## 39.2.3 PMD signal detect function

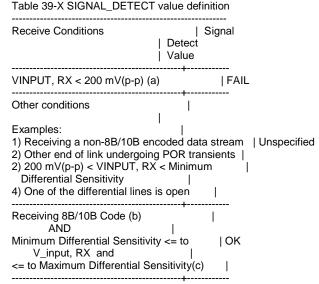
The PMD Signal Detect function shall report to the PMD service interface, using the message PMD SIGNAL.indicate(SIGNAL DETECT) which is signaled continuously. PMD SIGNAL is intended to be a rough indicator of signal presence. SIGNAL DETECT shall be set to OK when the PMD circuitry receives a valid electrical signal. SIGNAL\_DETECT shall be set to FAIL when the received electrical input power level is below -30 dBm. Examples of a FAIL condition are when the link is unplugged or the transmitter to which it is attached is turned off. Under all other conditions, the state of SIGNAL\_DETECT is unspecified.

Under all valid operating conditions there shall be no false positive OK indications. Though unspecified, this implies that there must be adequate margin between the SIGNAL DETECT trip point and the inherent noise level of the PMD due to cross talk, power supply noise, etc. Under all valid operating conditions, an incoming signal at or above the Receive power (min) shall not indicate FAIL. Though unspecified, this implies that there must be adequate margin between the SIGNAL\_DETECT trip point and the receiver sensitivity minimum.

#### 38.2.4 PMD signal detect function

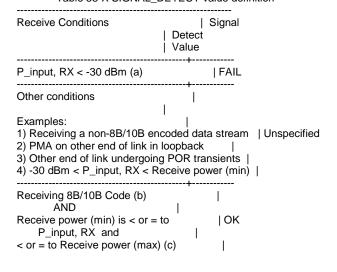
Note: SIGNAL\_DETECT = OK does not guaranty that rx\_bit is known good. It is possible for a poor quality link to provide sufficient light for a SIGNAL\_DETECT = OK indication and still not meet the 10-12 BER objective.
